FINAL AS-BUILT DRAWING SP-HCB-133-1
NO RD CHG'D REDLINE
W/O APVY OF LD PIPE
ENGR OR HIS DESIGNER
HANGER RE QC ACCEPTED
RE APVY, PH RE APVY

BECHTEL POWER CORPORATION
RECORD COPY
PENNSYLVANIA POWER & LIGHT COMPANY
RECORD COPY
SUBQUEHANNA STEAM ELECTRIC STATION - UNIT 1 UNIT 2

TITLE
FOR SUPPRESSION POOL WATER LEVEL INSTRUMENTATION
JOB NO 8856
DRAWING NO SP-HCB-133-1
REV 16

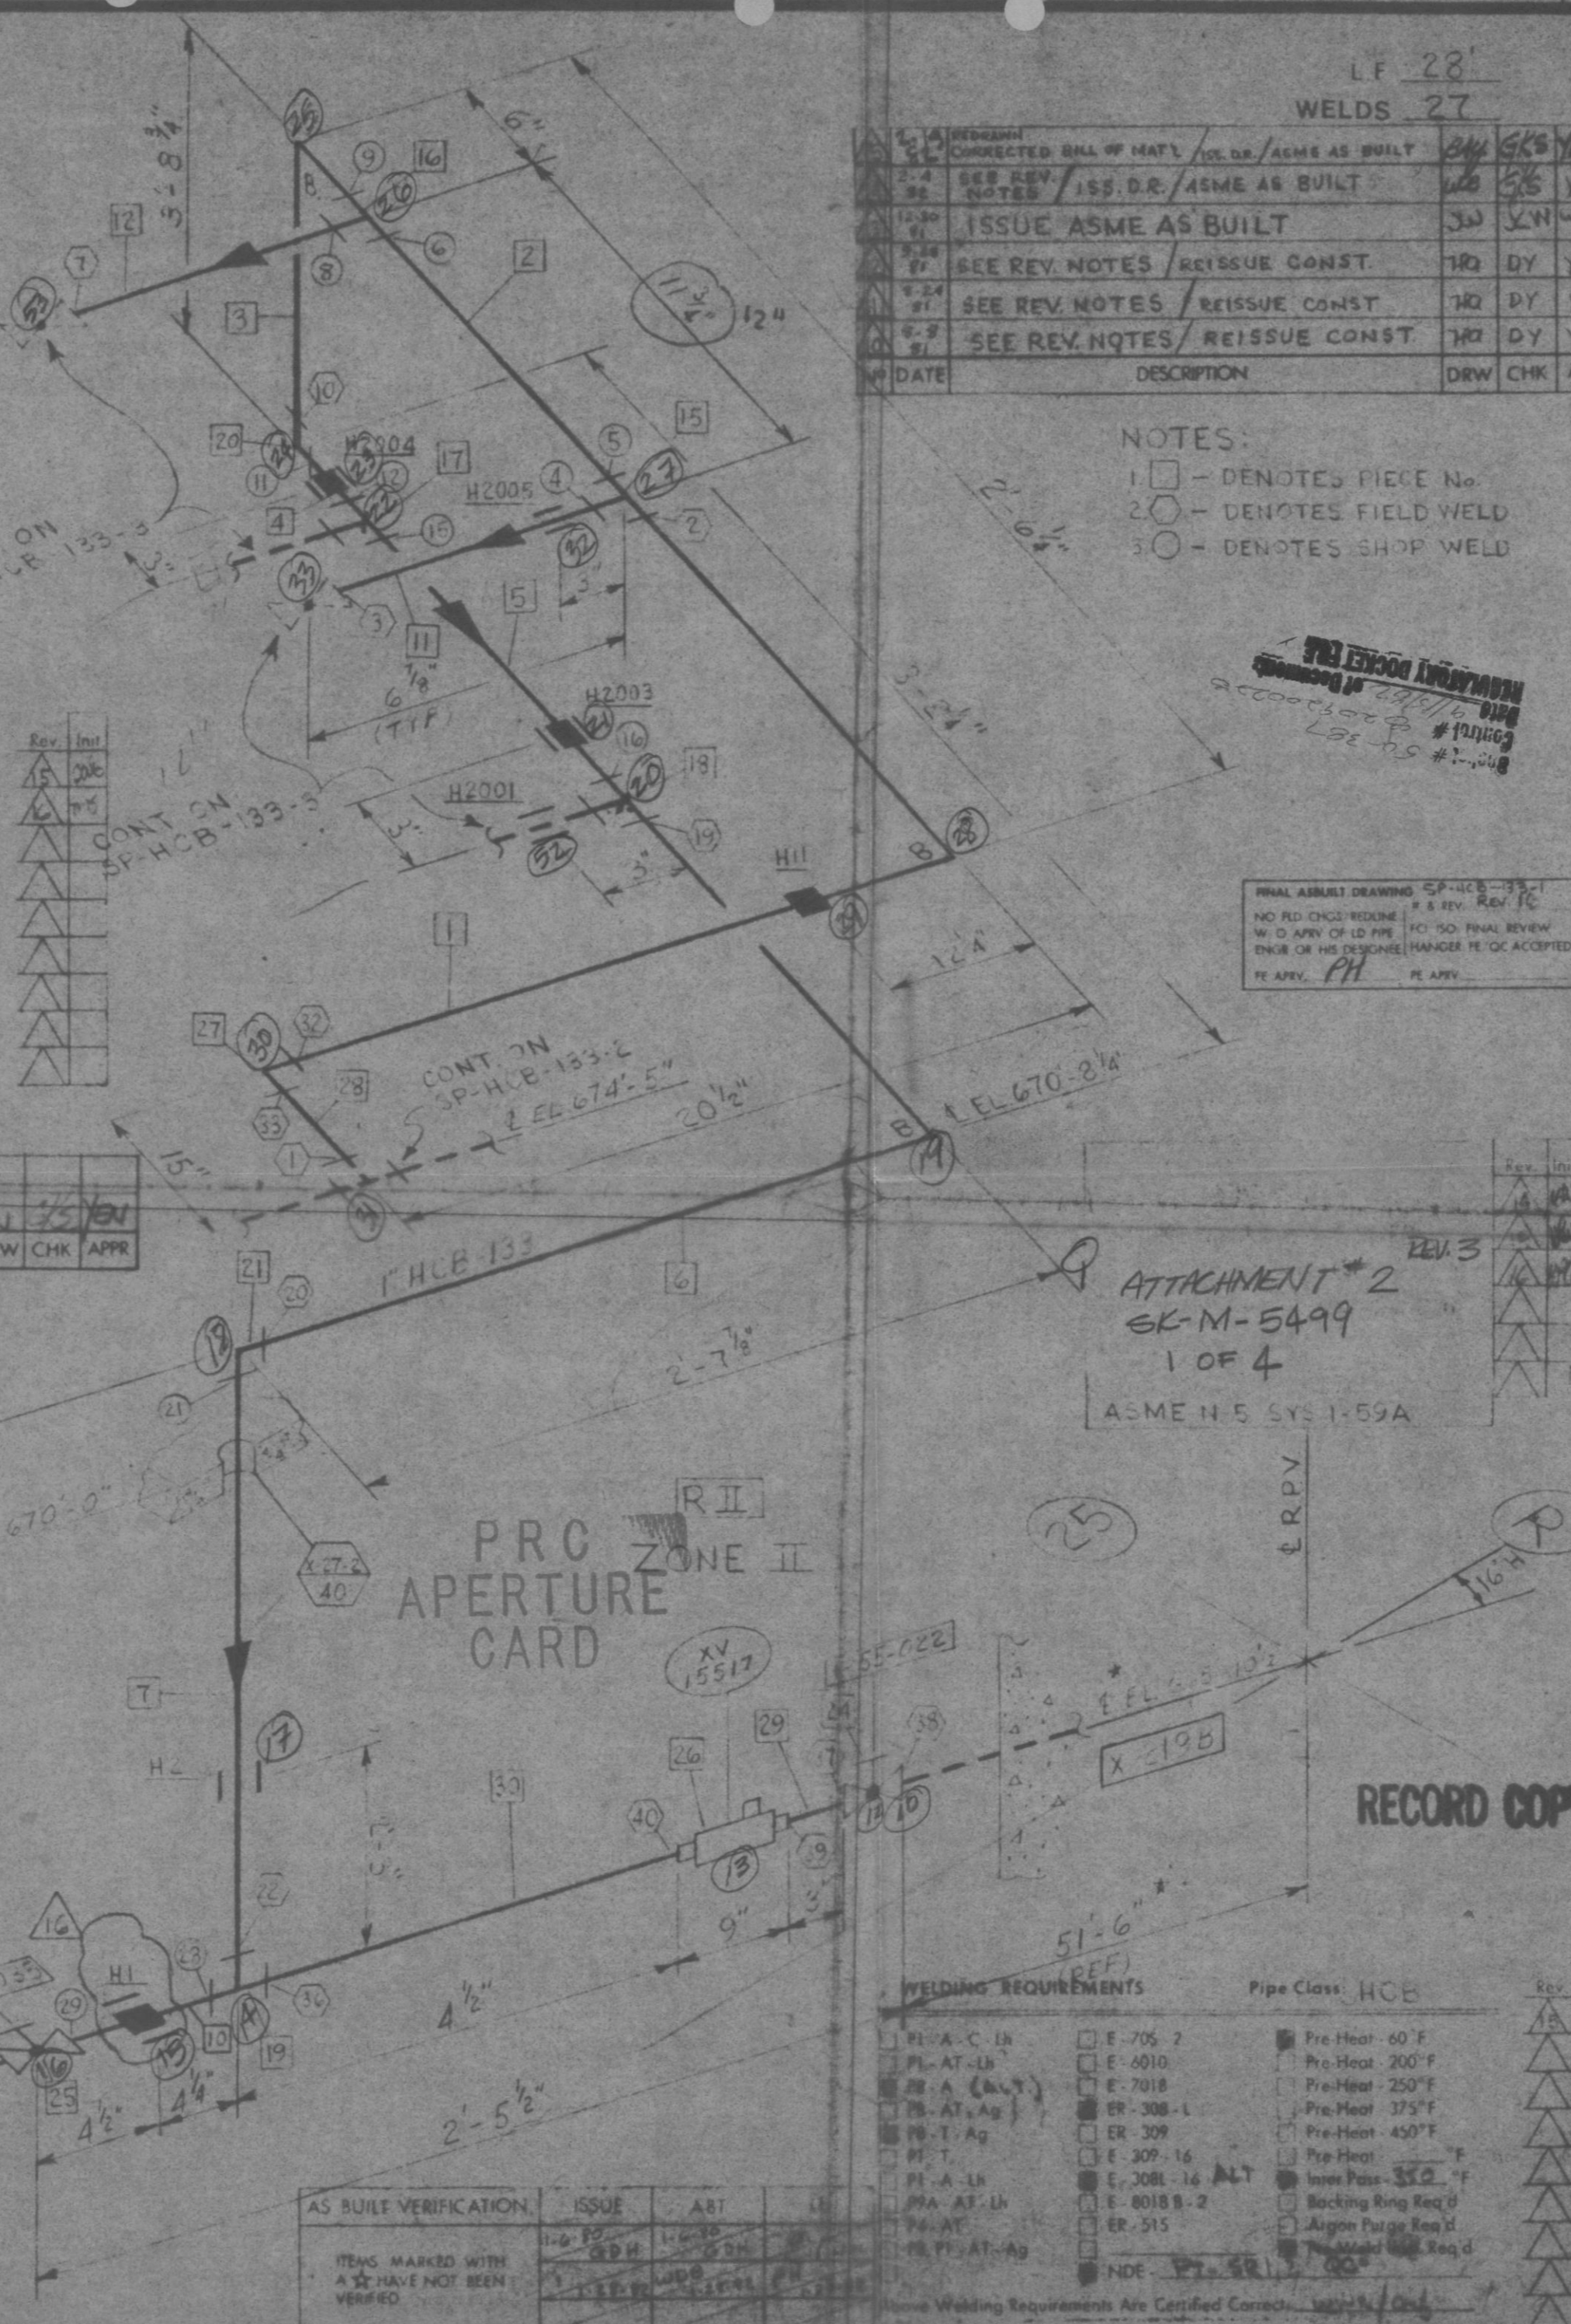
REV. 15 NOTES:
REINSTATED AS BUILT CONDITION VOICING REV 11 NOTES
REINSTATED WELDS 22, 32, 33
DELETED: PW 31, 32 WELD AT THRU 45
NOTE 4 REVISED FROM LF 1 SW TO COMPLY WITH EXISTING CONDITION. SWR 2437 HAS BEEN DELETED AND SWR 2399, 15 SUPERCEDED BY SWR 2369

REV. 16 NOTES:
DELETED: WELDS 22, 32, 33
ADDED: PW 31, 32
WELDS AT THRU 45
NOTE 4
REVISED BOM L.F. 304-5 SW
REVISED TAG PER SKR 23 1 Y
SWR 2457

REV. 17 NOTES:
DELETED HGRS H3 H5 H7 H9
ADDED HGRS H2001 H2003 H2004 H2005, CH 1 SYM FOR HI PER ENGR REV 9E1
DELETED: PW 13, 14
WELDS 13, 14, 17, 18
REVISED FOOTAGE NO OF WELDS 7
BOM CHG'D PER SWR 2324
